2005 5TH AVE

EARLY DESIGN GUIDANCE #3
PROJECT NUMBER: 3028017-EG
MEETING DATE: 01/04/2022

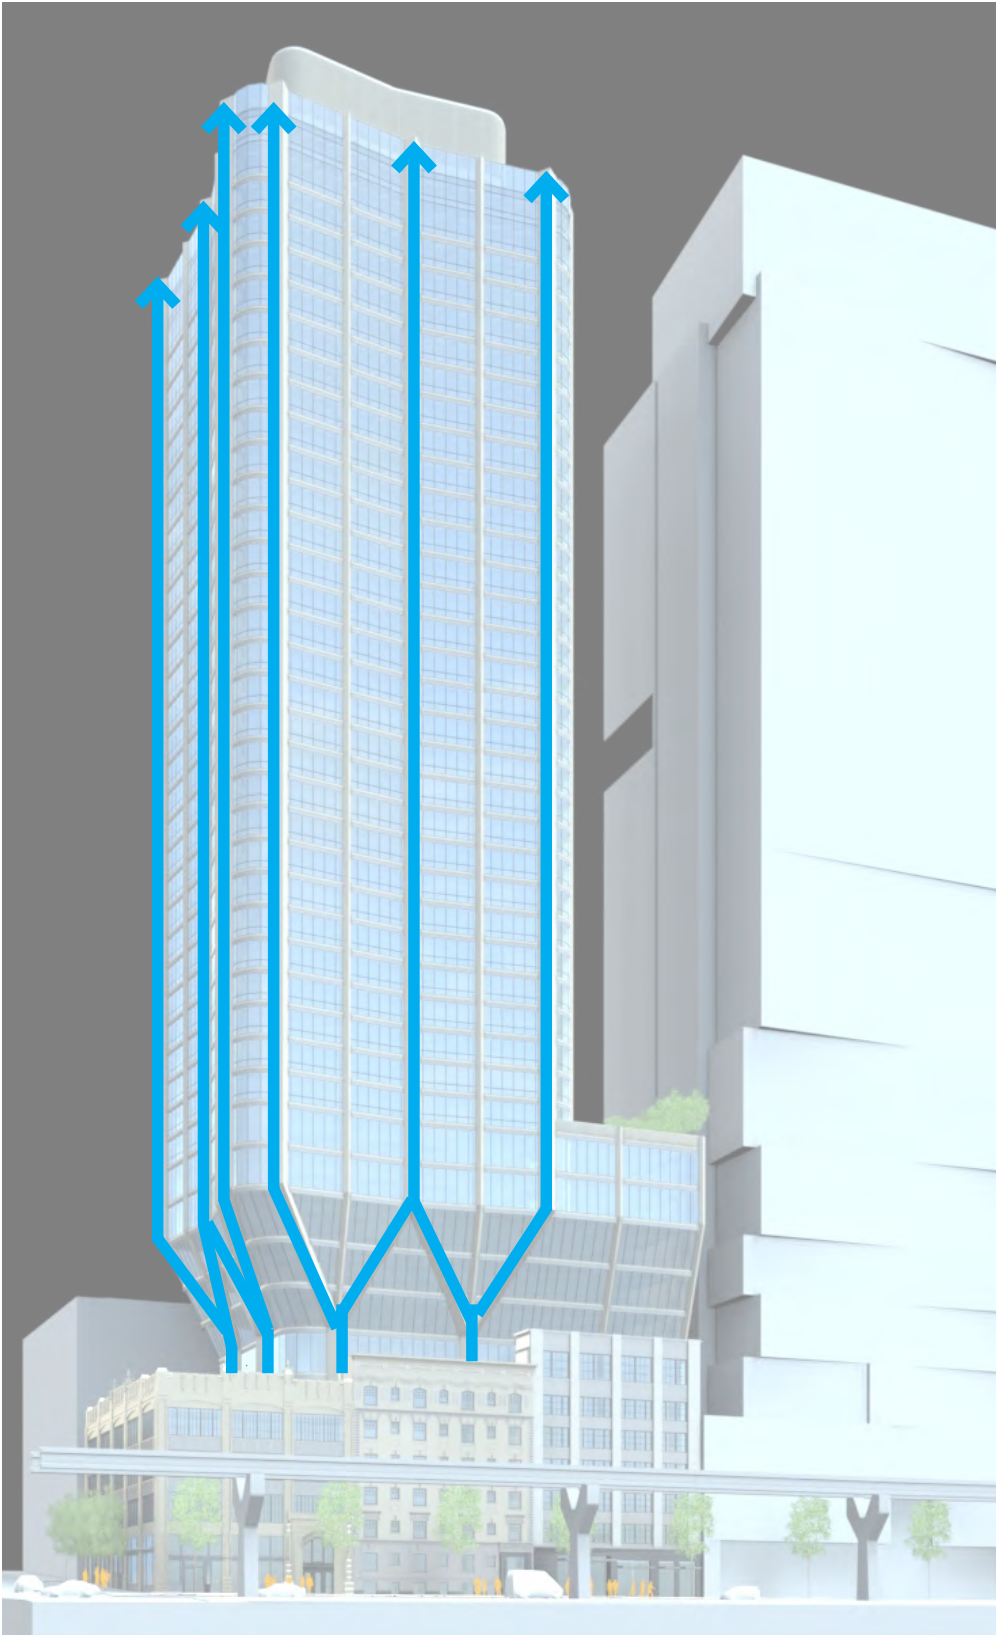
The Board requested greater resolution and study of the transition from tower to podium, noting the new podium did not yet support a unified building expression including both the existing historic structures and proposal.

The study of the transition from the tower to the podium now creates a unified building expression and is compatible with the existing historic structures. Refined the spatial relation of the "Y's" columns so they correspond better to the verticalness of the historical buildings and the width of the tower, whilst maintain proportionate to the size of the new podium.

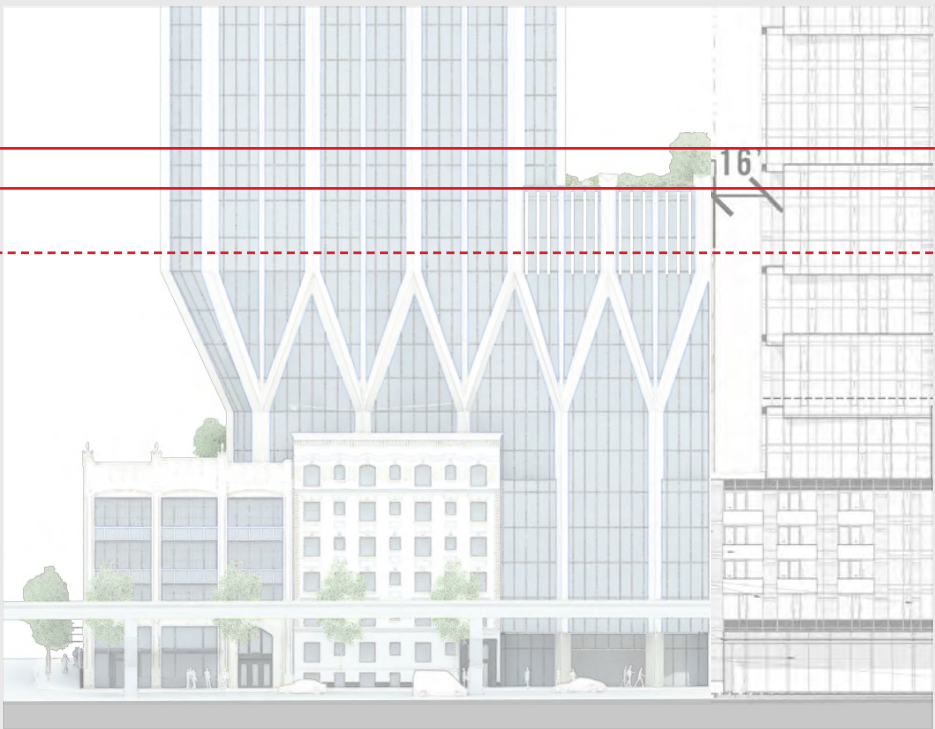
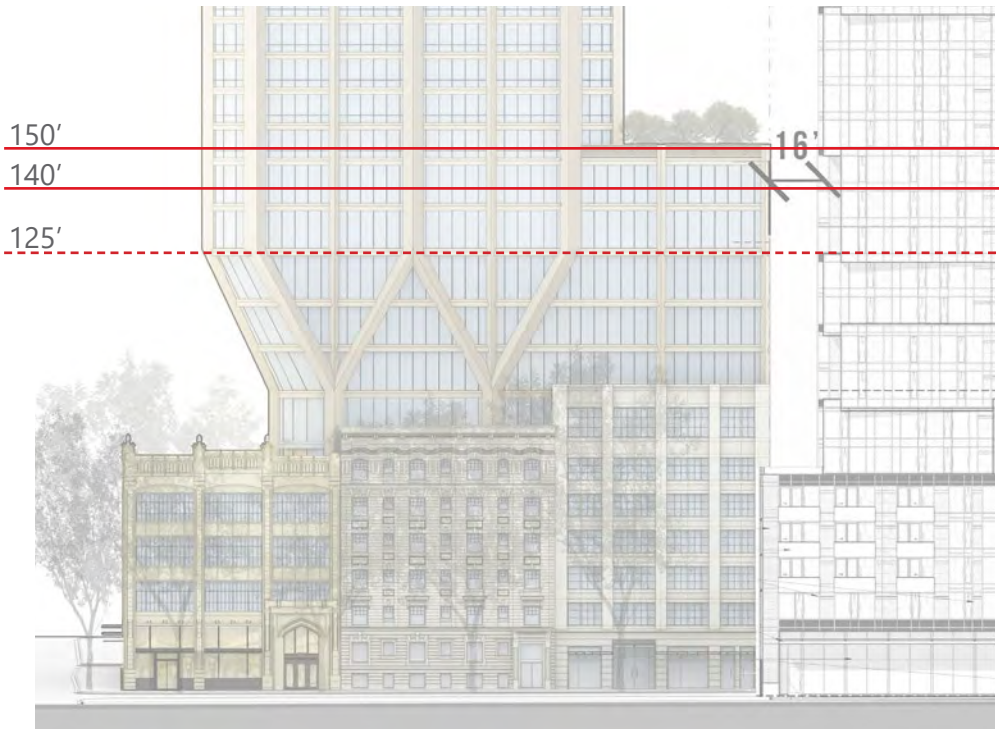
- 3.a.iii.
- The Board requested further study of the relationship between the 2 additional floors at the upper podium level and the adjacent building. The Board requested the following:
1. Look at increasing this setback greater than the proposed 16'
 2. Provide window overlay study, sections, light and shadow studies

The relationship between the 2 additional floors at the upper podium levels and the adjacent building is refined by decreasing the height and incorporating a two-level setback at the alley on the NW. Based on shadow studies, more solar access is created in the revised design.

MASSING-PODIUM

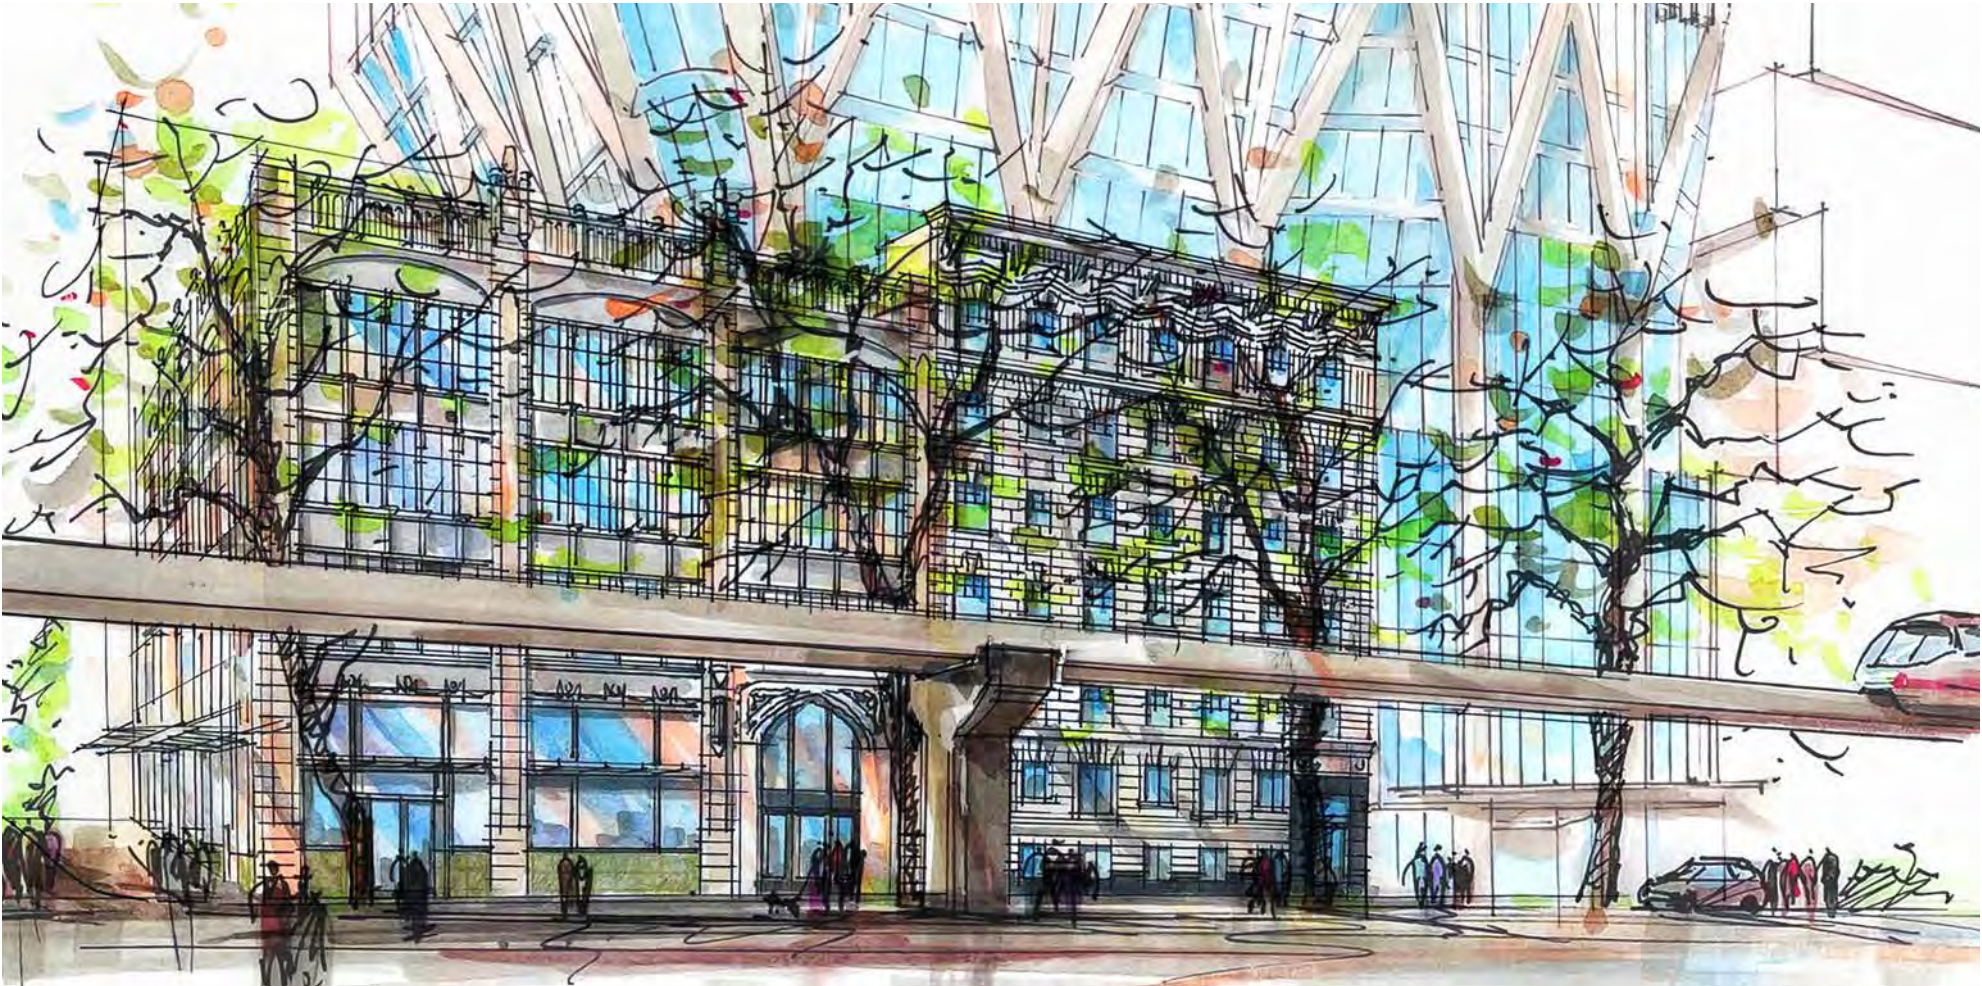
3.a.ii.
The Board suggested simplifying the new podium to relate more to the tower language could be a better solution than adding yet another facade expression.

The podium has been revised using a simplified language relating to the tower extending the New Formalism concept to the ground, providing a neutral backdrop for the existing Landmarks. This neutral glass treatment contrasts with the existing landmarks, much like in the Kelly Springfield example referred to the team by the board.
